City of West Linn
PRE-APPLICATION CONFERENCE MEETING
December 3, 2009

SUBJECT: Replacement of existing facilities at West Linn High School baseball field including bleachers, plus new facilities including bathrooms and concessions, additional fencing, relocating utilities, improved access and ADA accessibility, and the addition of an announcer's booth at 5464 West A Street (Assessor's map 22E 30 tax lot 800).

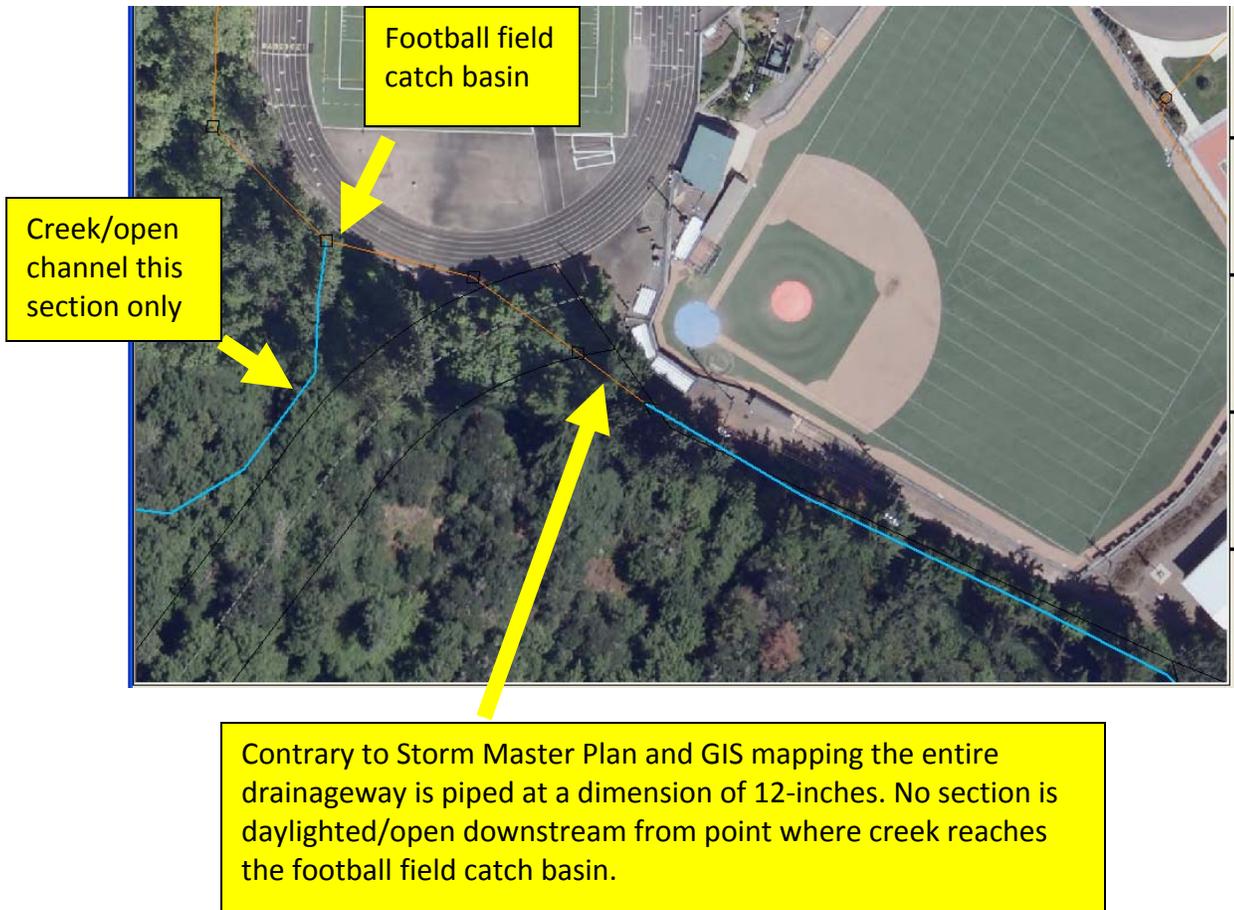
Catch basin at base of hill where pipe heads south east towards I-205. No open channel/stream exists along gravel driveway where other catch basins were noted. Corridor on school property is clearly developed and non-natural.
